REVS:
CODE: 2003
TOWN: PORTLAND
DATE: 05 JUL 06
SCALE: AS NOTED
DRAWN: JJO
TITLE: SECOND FLOOR & ROOF FRAMING PLANS
FILE: 06-0017
SHEET: A4

2 Roof Floor Framing Plan
1/4" = 1'-0"

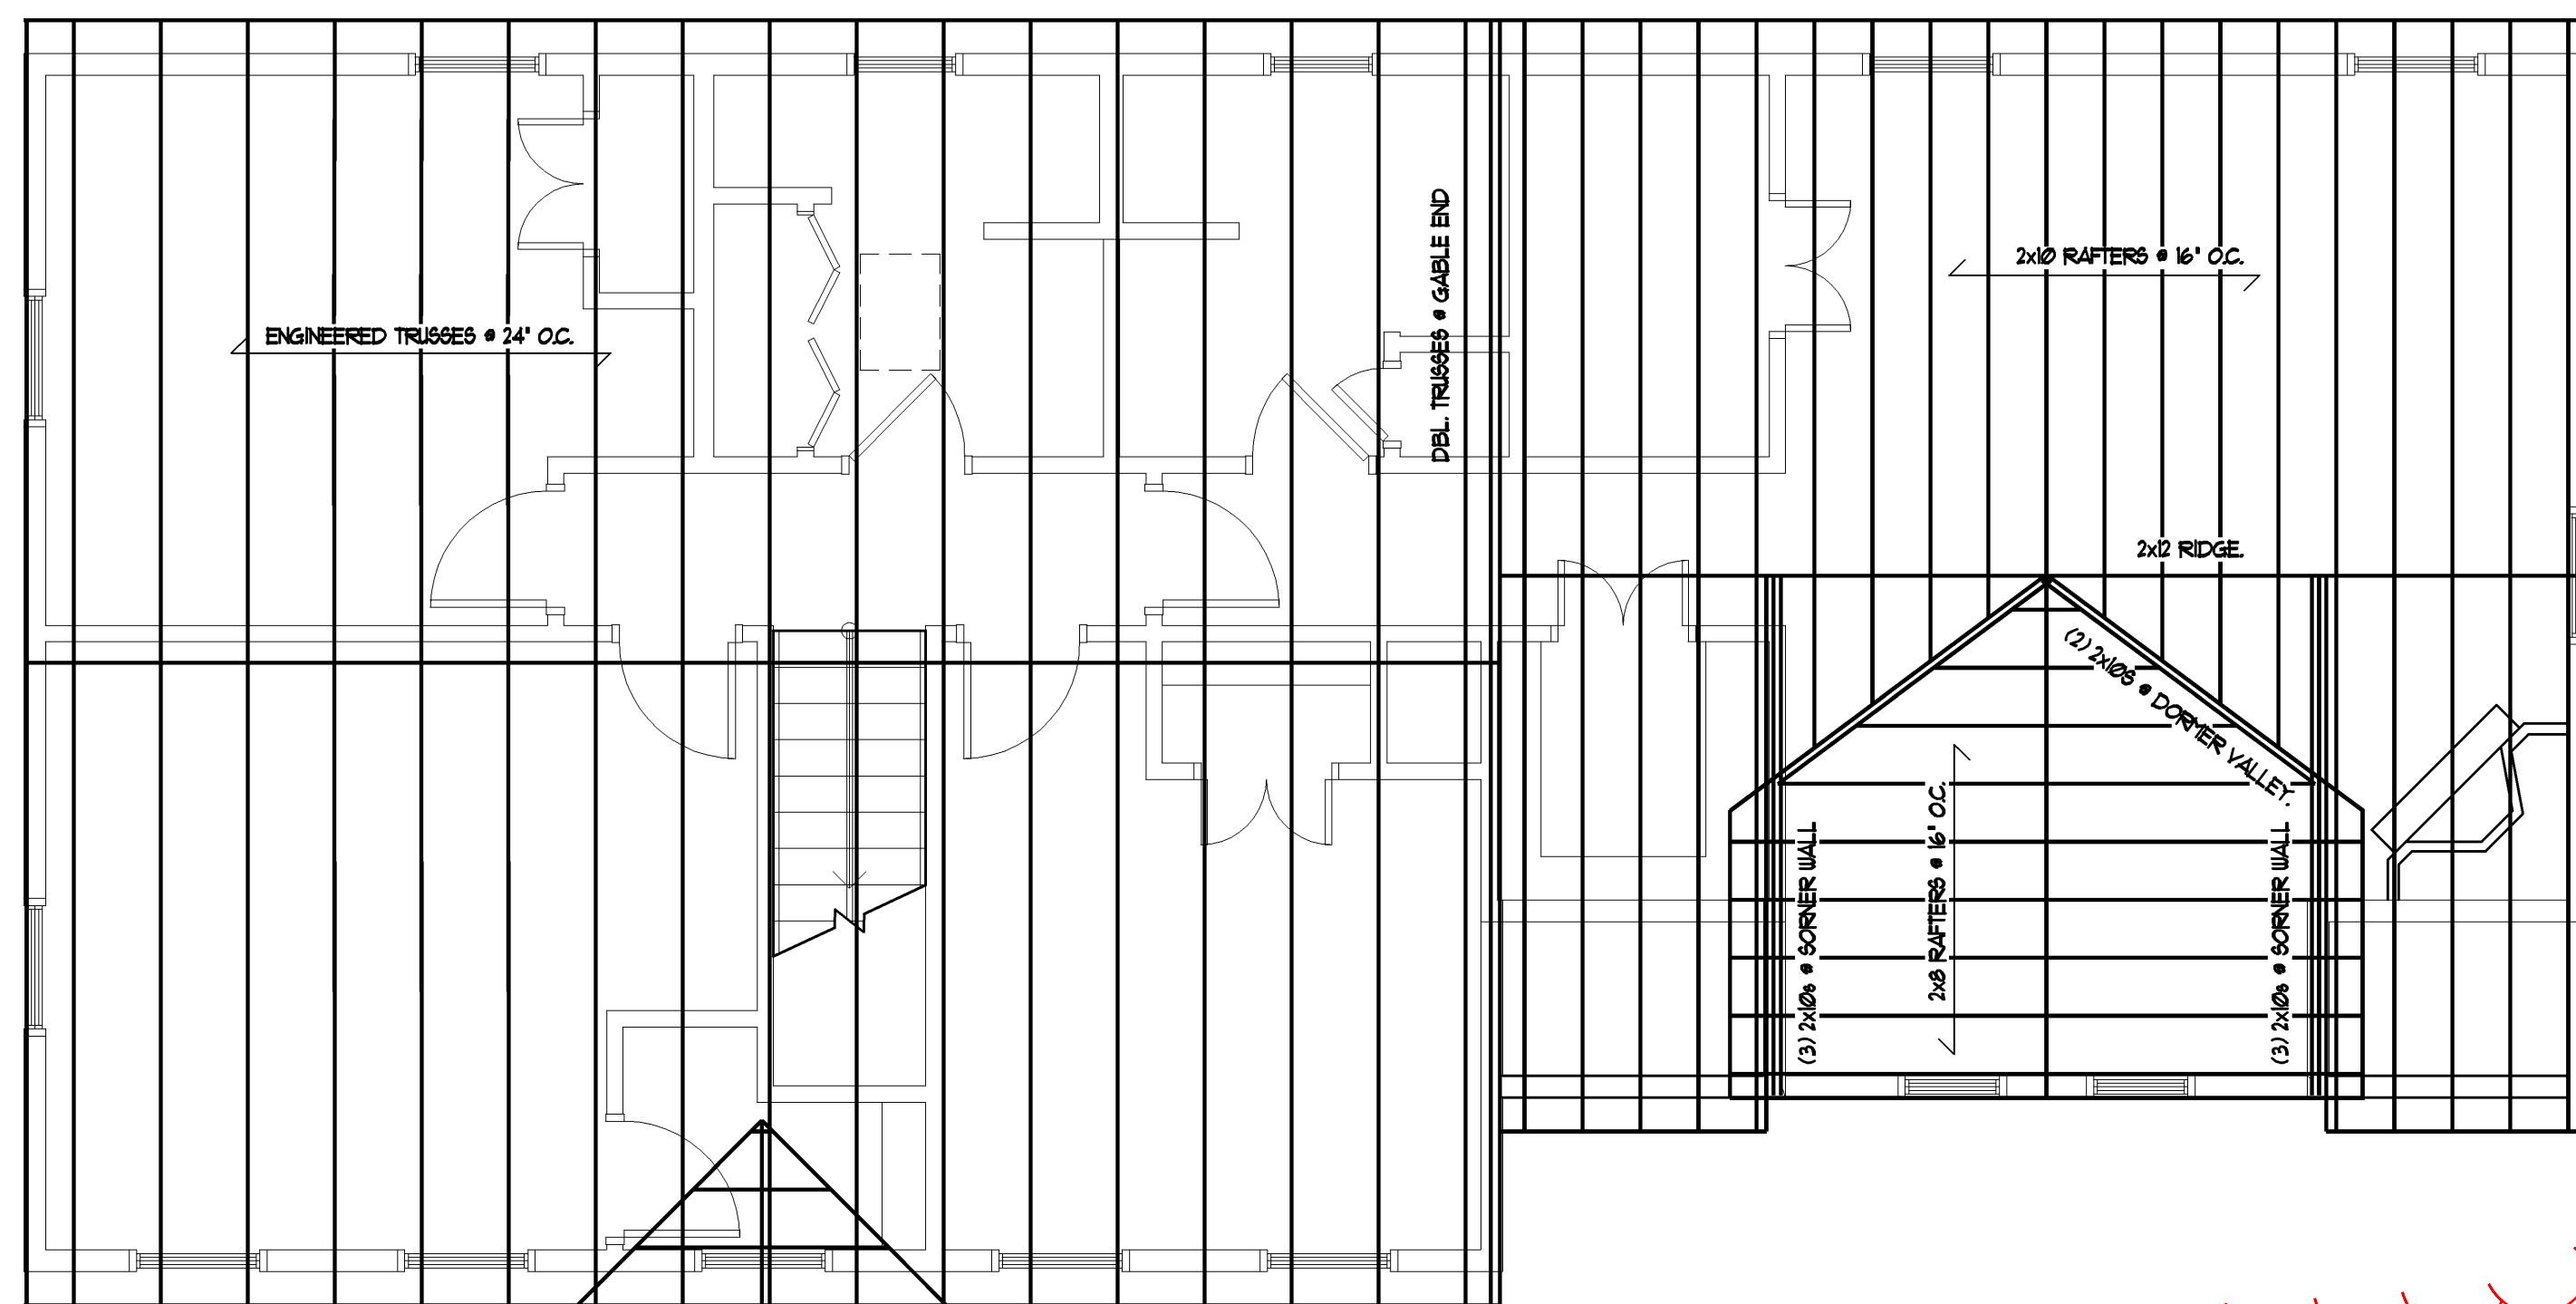
Added roof framing plan (yellow box)
